Architect's Supplemental Instructions

PROJECT:
Summit Square
Apartments Phase II
 837 NW Donovan Road
 Lee's Summit, MO 64086

ARCHITECT'S SUPPLEMENTAL
INSTRUCTION NO.: 16

At the Owner's request, an addition to serve as the Parcel Storage room was added to Building 1. Additional revisions and clarifications to the scope are summarized per sheet, and reason for the change where applicable:

A2.11B

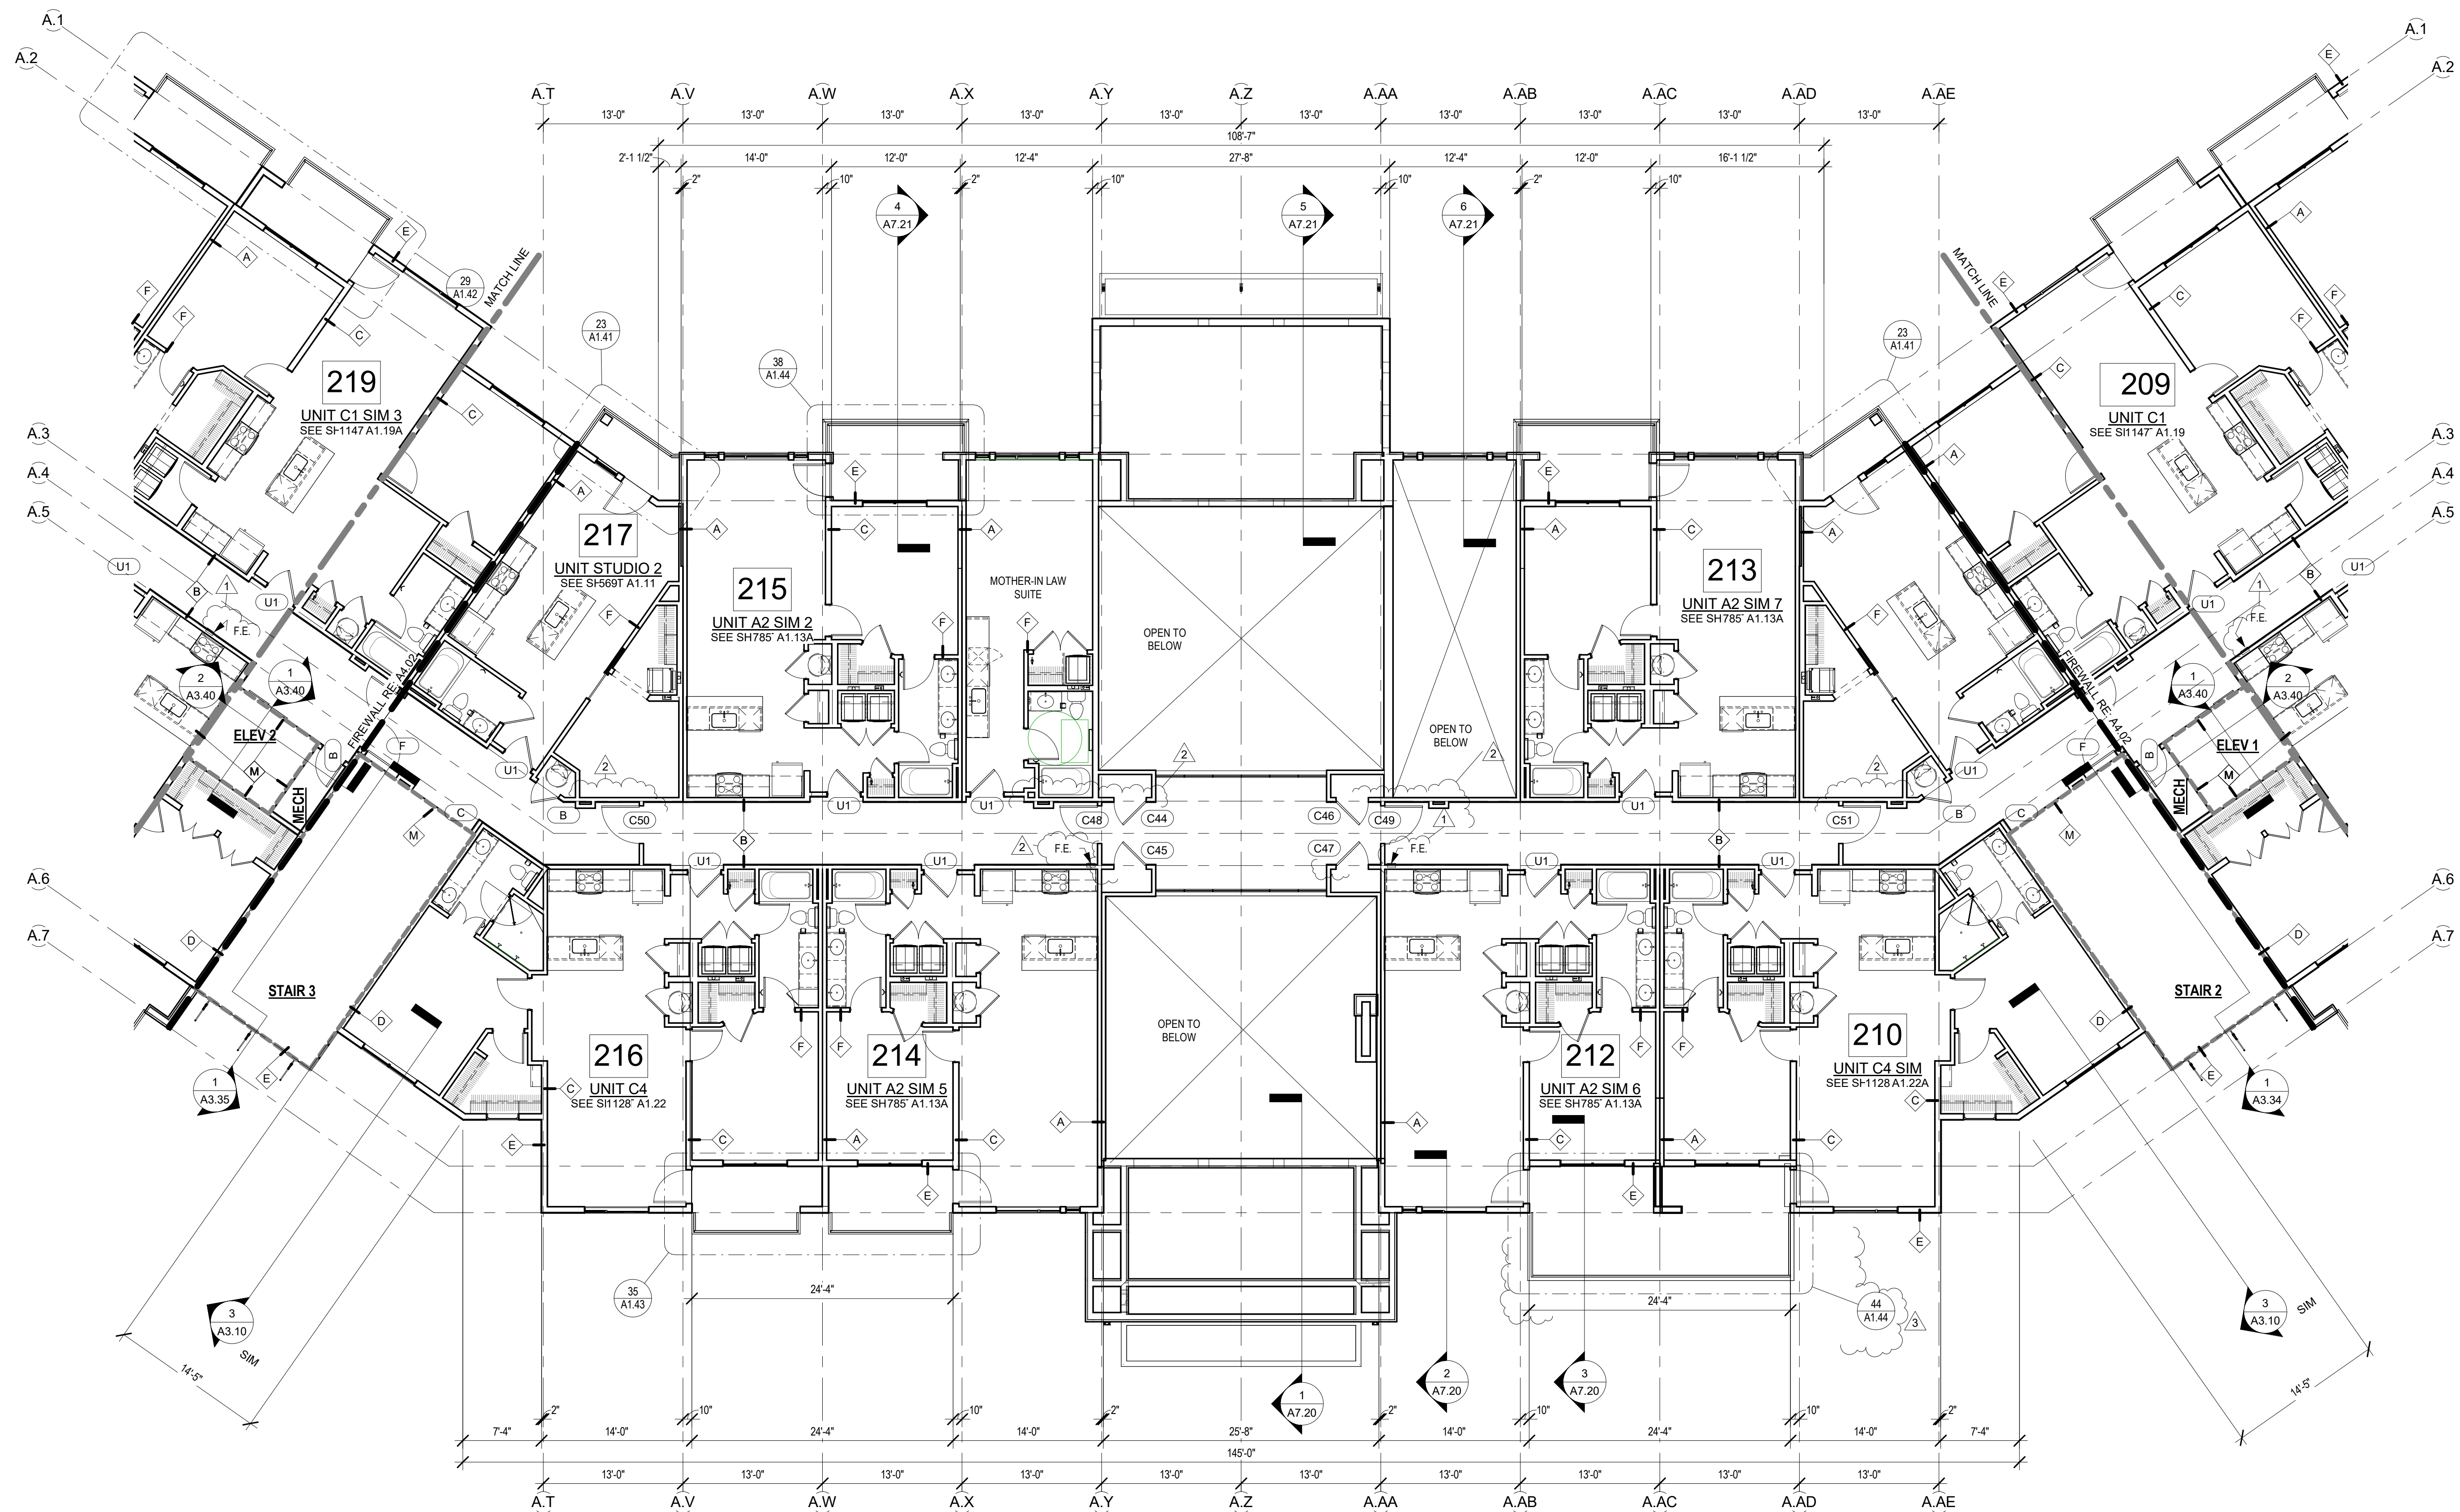
- A2.10B *Revised with Parcel Storage room addition*
- A2.10SB *Revised with Parcel Storage room addition*
- A2.11B *Revised with Parcel Storage room addition*

A2.15B

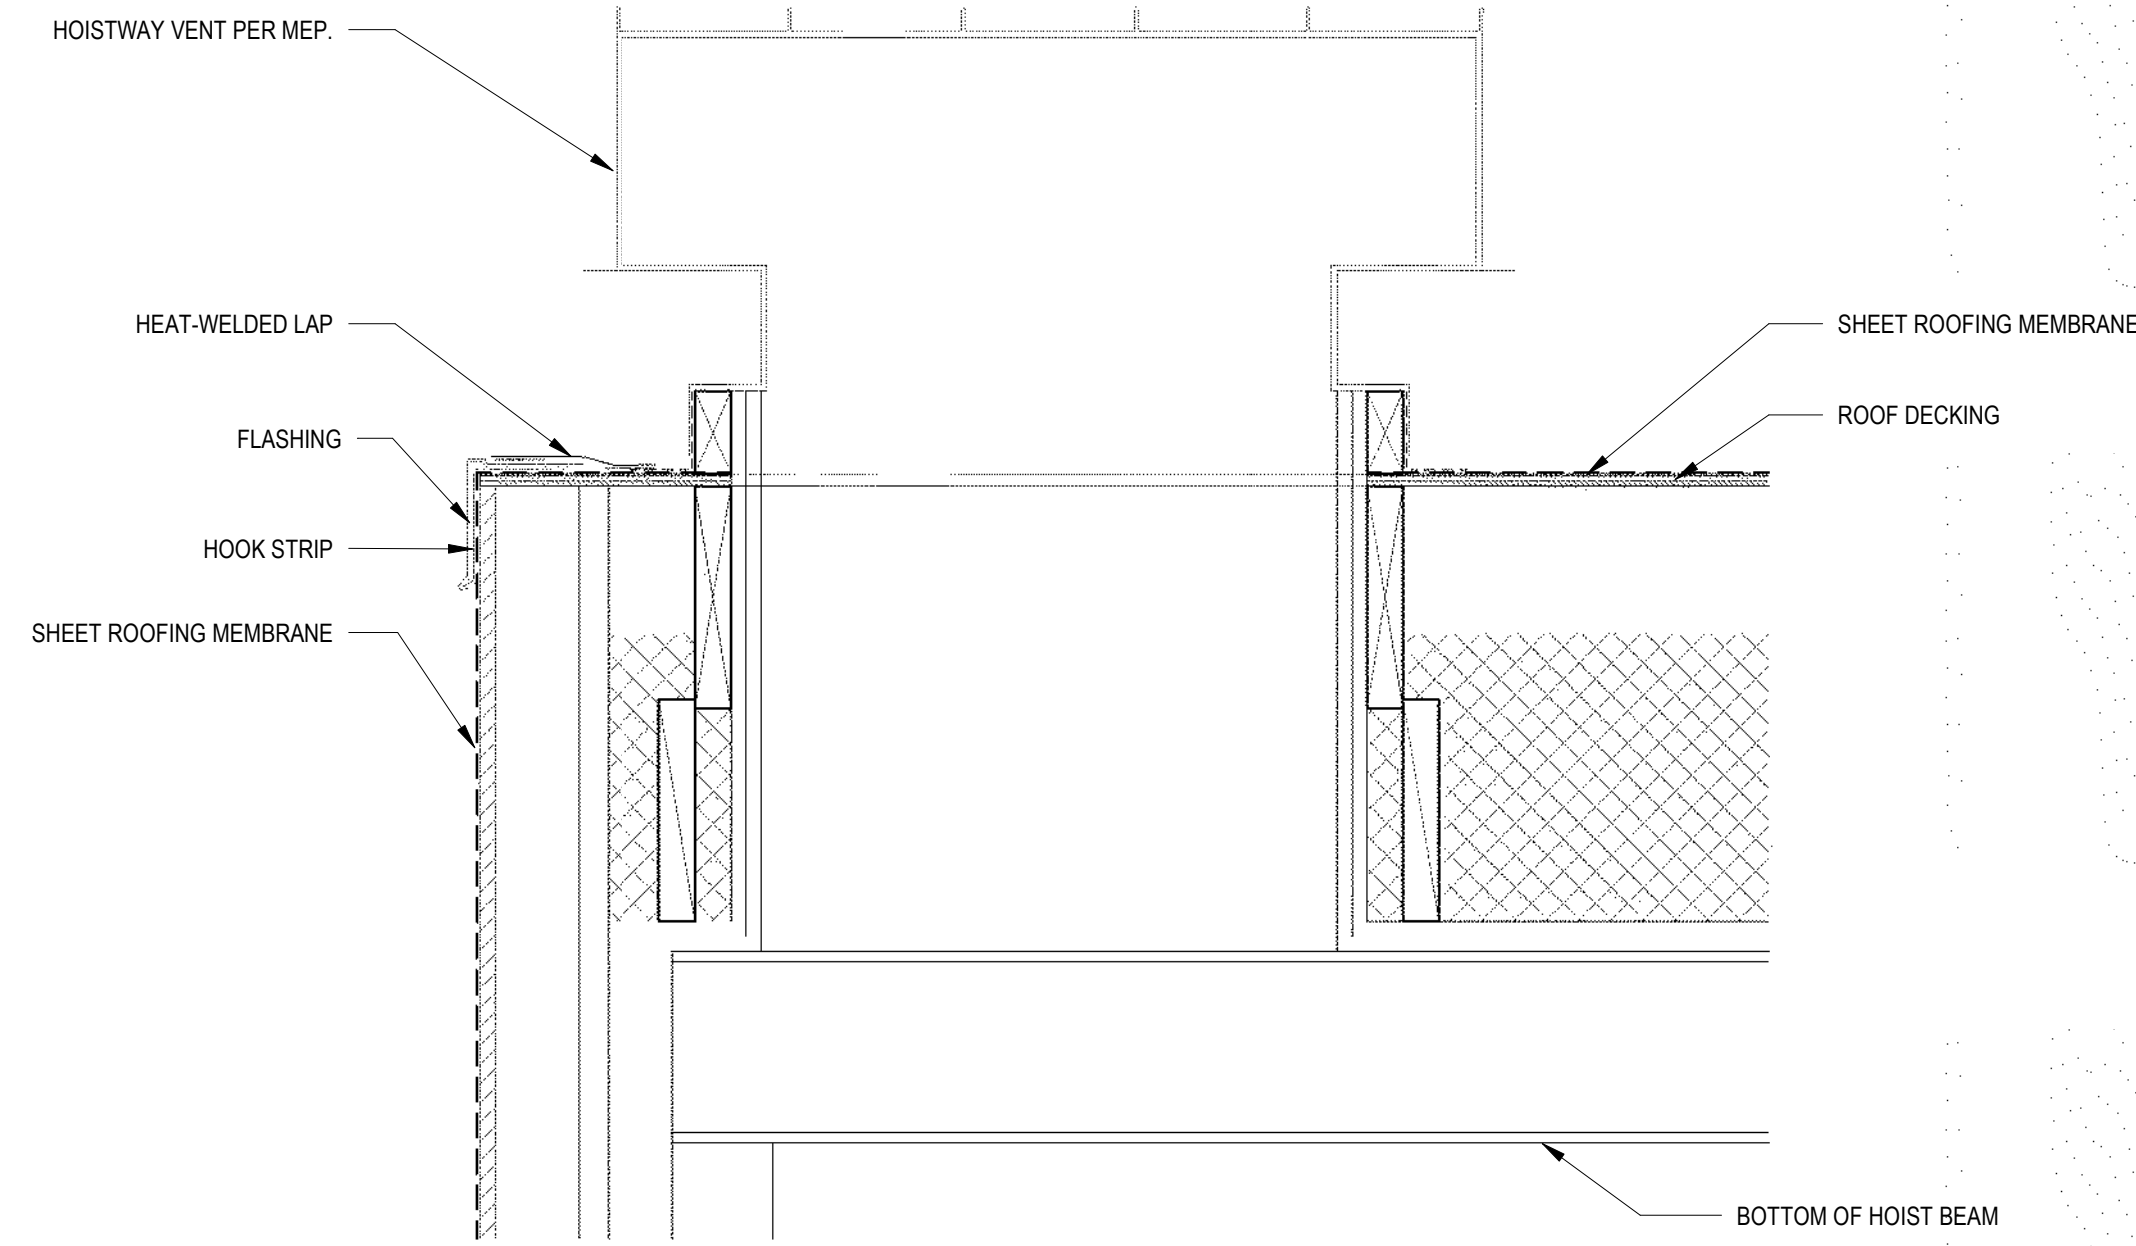
- A2.15B *Revised Elevation for Parcel Storage room addition*
- A3.40 *Document Elevator Beam Height change (as indicated on Elevator Shop Dwgs)*
- A3.41 *Document Elevator Beam Height change (as indicated on Elevator Shop Dwgs)*
